**Submission from NSW Masonic Club – Castlereagh Boutique Hotel to the Director of Transport Assessments, Department of Planning and Environment Regarding the Sydney Metro City & Southwest – Chatswood to Sydenham Environmental Impact Statement (SSI 15\_7400)**

Submission from NSW Masonic Club –  
Castlereagh Boutique Hotel to Director,  
Transport Assessments, Department of  
Planning and Environment Regarding the  
Sydney Metro City & Southwest -  
Chatswood to Sydenham Environmental  
Impact Statement  
(SSI 15\_7400)

ASSESSMENT OF THE ACOUSTIC EFFECTS OF  
THE PROPOSED CONSTRUCTION OF THE  
SYDNEY METRO CHATSWOOD TO  
SYDENHAM LINE ON THE CASTLEREAGH  
BOUTIQUE HOTEL

FIGURE 3 – RELATIONSHIP OF THE METRO PROJECT SITE TO THE CASTLEREAGH BOUTIQUE HOTEL

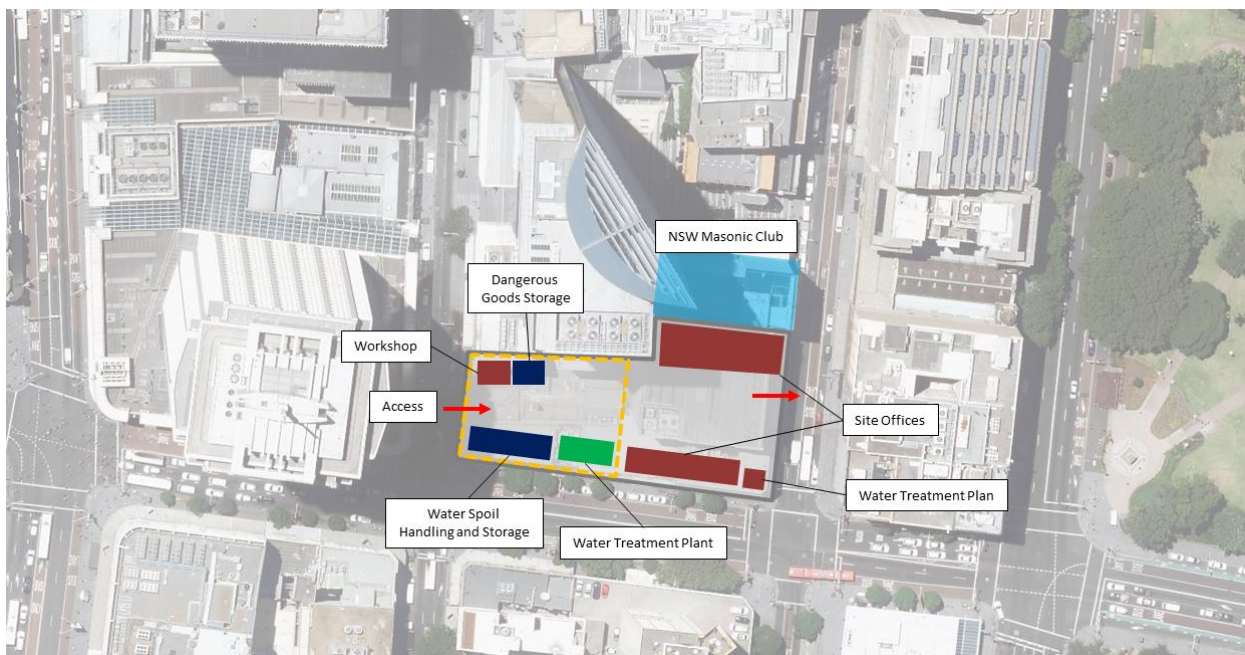
The level of information provided with the EIS to describe the construction process is very preliminary and schematic and inadequate to properly assess the implications of the project.

It is understood that the construction program would commence in 2017 and likely extend to 2024. Given the identified staging of construction, the NSW Masonic Club and Castlereagh Boutique Hotel would be most significantly impacted between 2018 to 2022, as tunnel construction, station demolition, excavation and structural works, station construction and fit out occurs. In other words some 4 years of construction impacts.

The EIS identifies that the Pitt Street north site would cover about 3,100sqm. The station could be constructed using a mined technique, with shafts excavated within the two sites to provide the future station entry and vertical transportation. It is estimated that approximately 160,000 cubic metres of spoil would be removed for the construction of the Pitt Street Station.

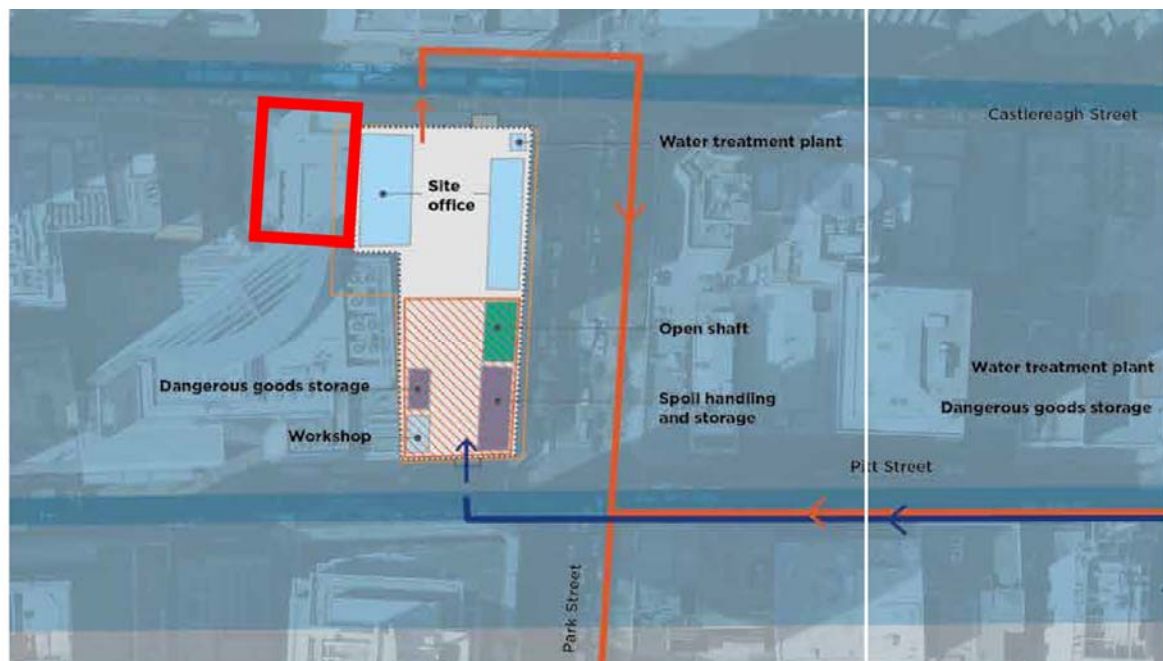
The Castlereagh Hotel is located directly adjacent to the northern Pitt Street as shown outlined in red below.

It is proposed that access into the construction site adjacent to the hotel is primarily achieved by a right turn in from Pitt Street (as shown in blue) and exit is achieved by a right turn out into Castlereagh Street as shown in orange.

It is assumed therefore, although it is not explicit in the EIS, that construction traffic passes through the construction site as shown below. This would mean that the primary construction traffic on my assumed yellow route would not pass the hotel site.

However, it is noted that in other plans, Castlereagh Street is proposed as a secondary route for construction traffic. This would mean that the secondary construction traffic would pass the hotel site.

Figure 8-38 Pitt Street Station construction vehicle movements

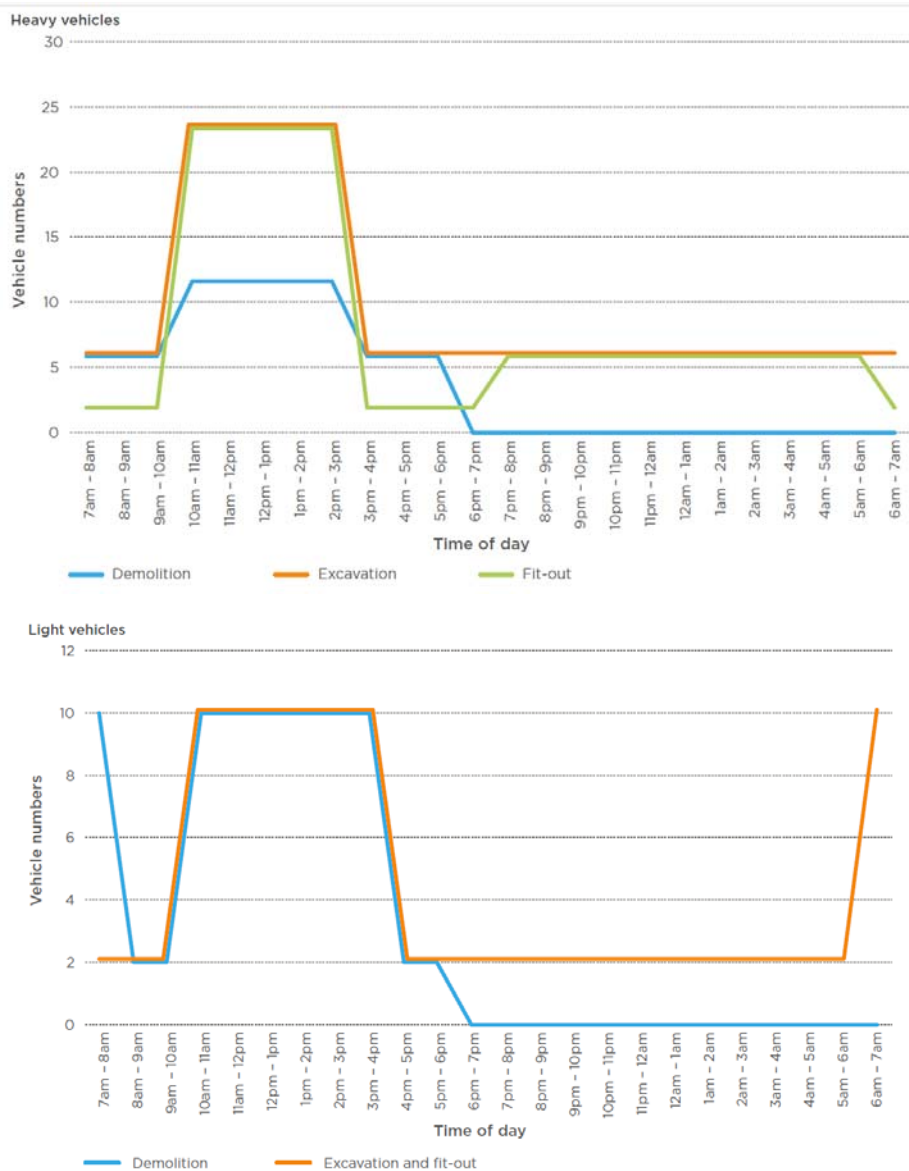
The figure of 234 excavation trucks would over a typical working day of, say 10 hours, would equate to around 3 trucks per minute which if split equally between the two sites would mean one truck leaving the site adjacent to hotel every 6 minutes throughout the working day.

It is noted that construction vehicles will load and unload inside the construction site to minimise impacts to bus travel times along Elizabeth, Castlereagh and Park streets so there will be **no construction trucks parked on-street along Castlereagh Street.**
